PROJECT REFERENCE NO.	SHEET NO.
I-5878	UC-7C
DESIGNED BY: DMP	
DRAWN BY: DMP	
CHECKED BY: DMP	
APPROVED BY:	
REVISED:	
NORTH CAROLINA DEPARTMENT OF TRANSPORTATION	
UTILITIES ENGINEERING SEC. PHONE: (919) 707-6690 FAX: (919) 250-4151	
UTILITY CONSTRUCTION PLANS ONLY

### UTILITY CONSTRUCTION

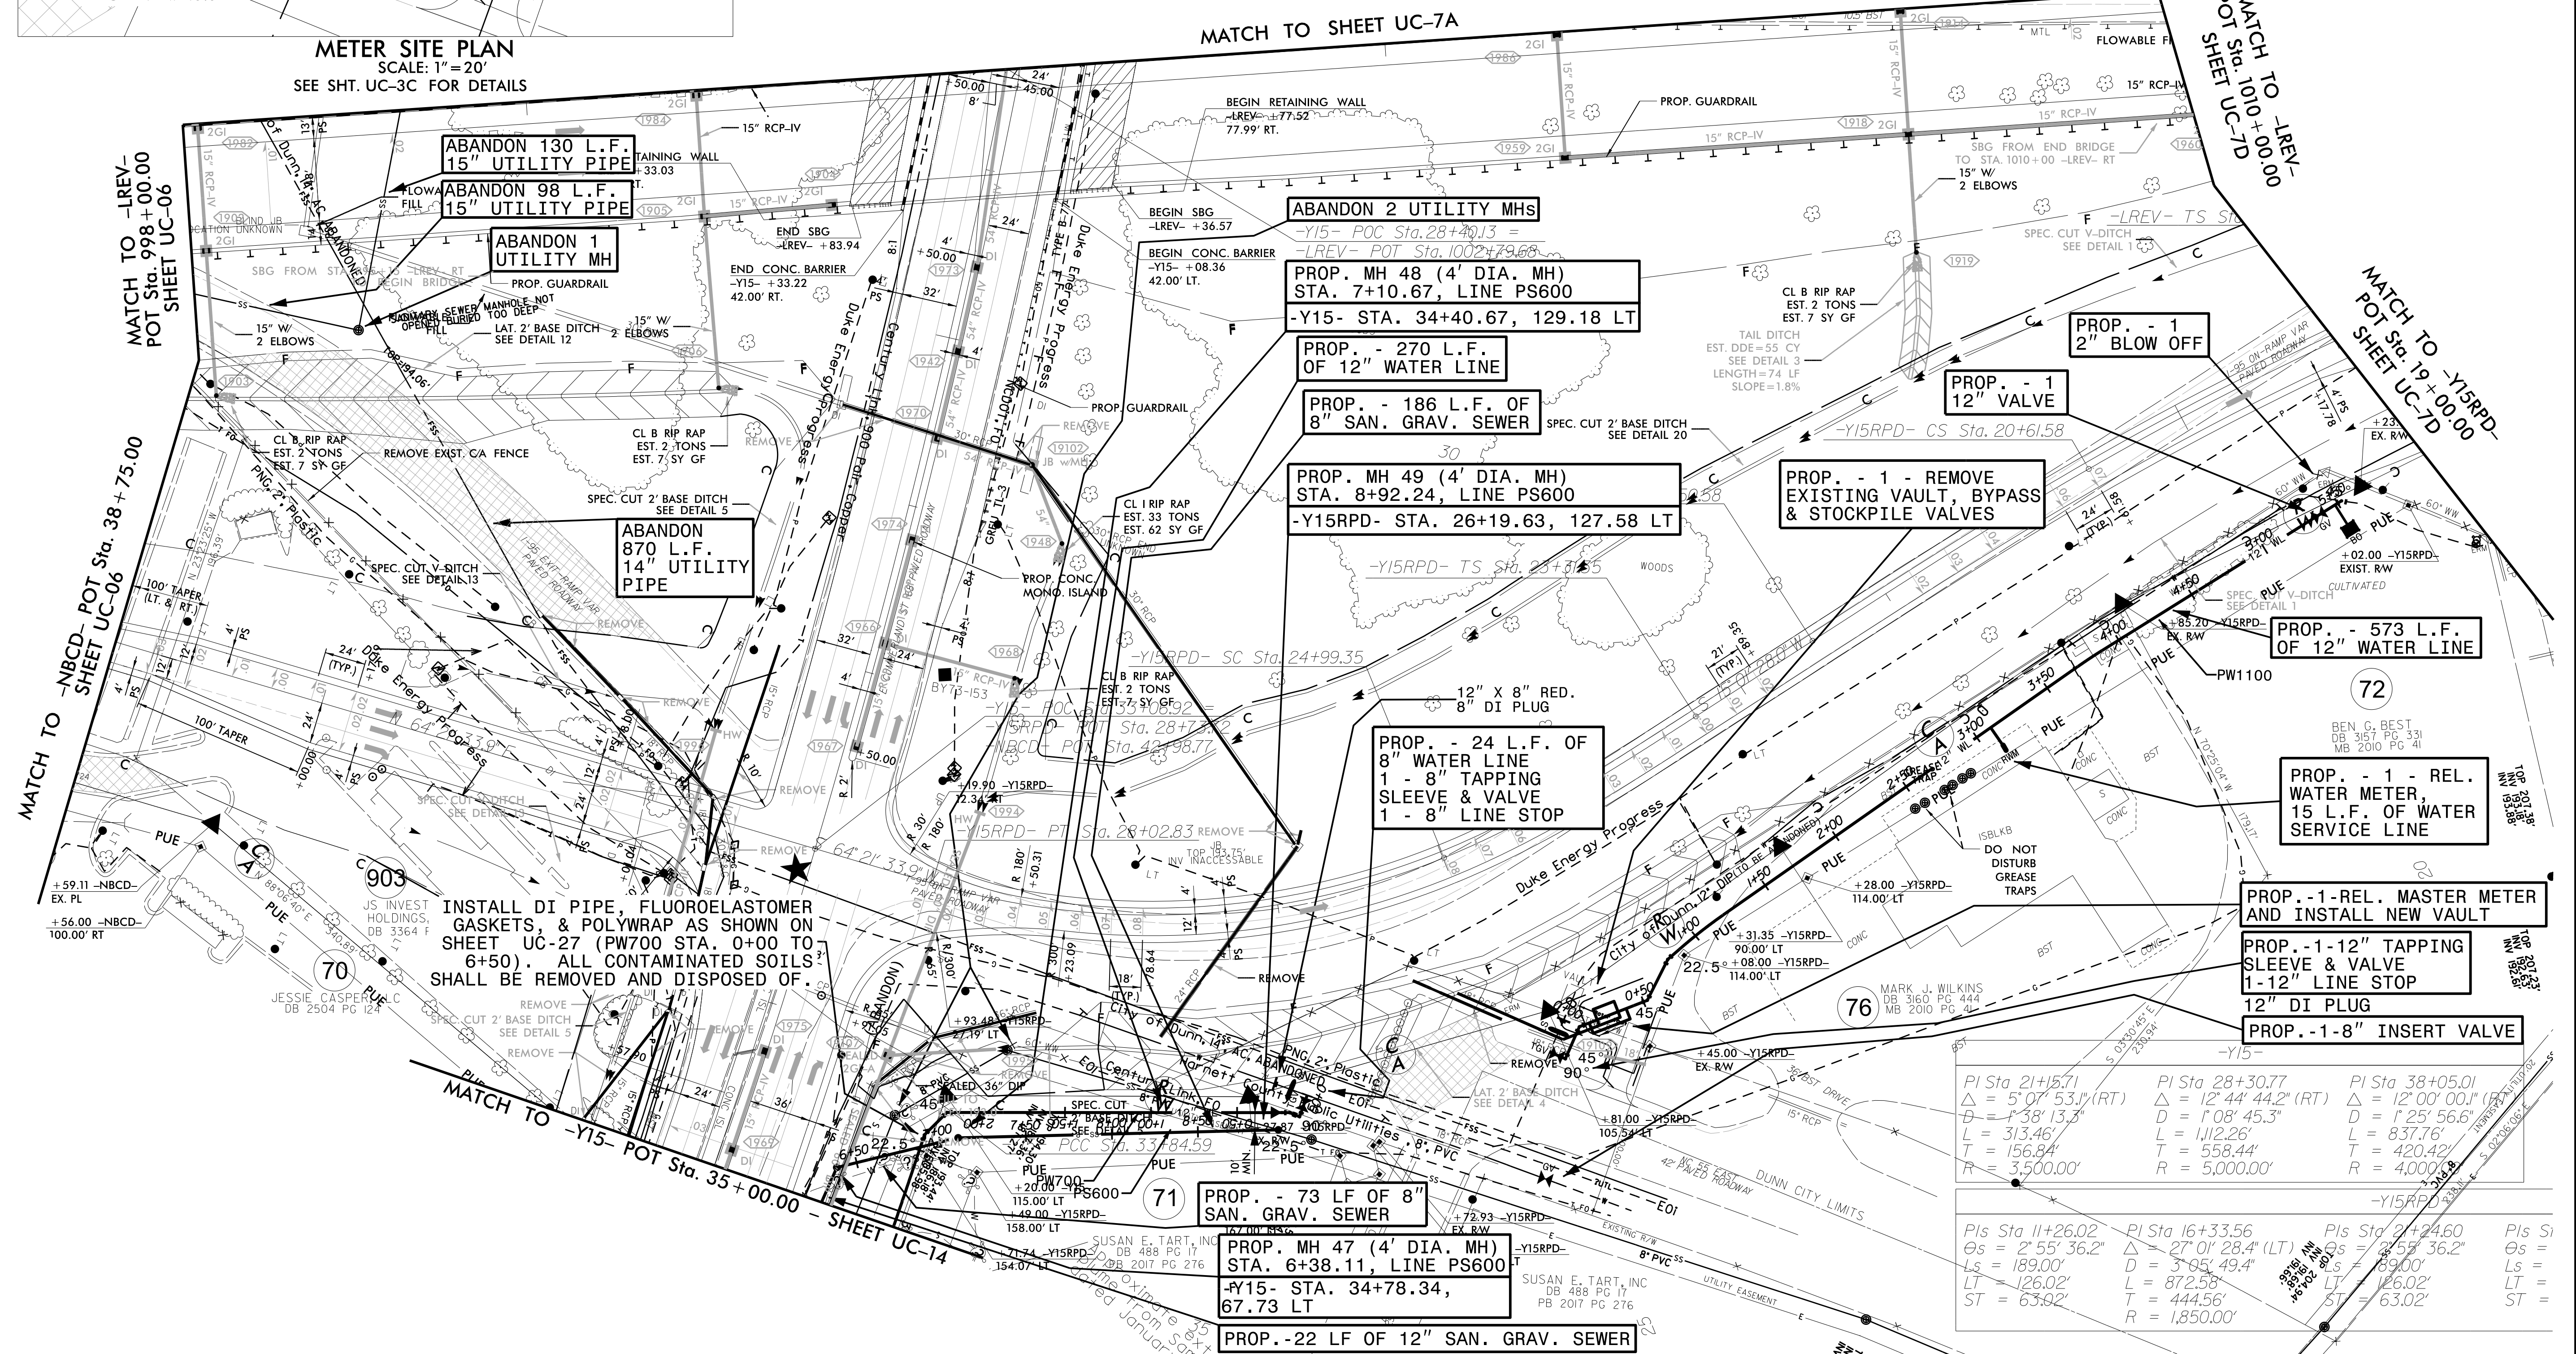
REVISIONS  
1. 06/21/2021 - ADDED FLUOROELASTOMER GASKETS TO PW700 FROM STA. 0+00 TO 6+50.

INSTALL DI PIPE, FLUROELASTOMER GASKETS, & POLYWRAP AS SHOWN ON SHEET UC-27 (PW700 STA. 0+00 TO 6+50). ALL CONTAMINATED SOILS SHALL BE REMOVED AND DISPOSED OF.
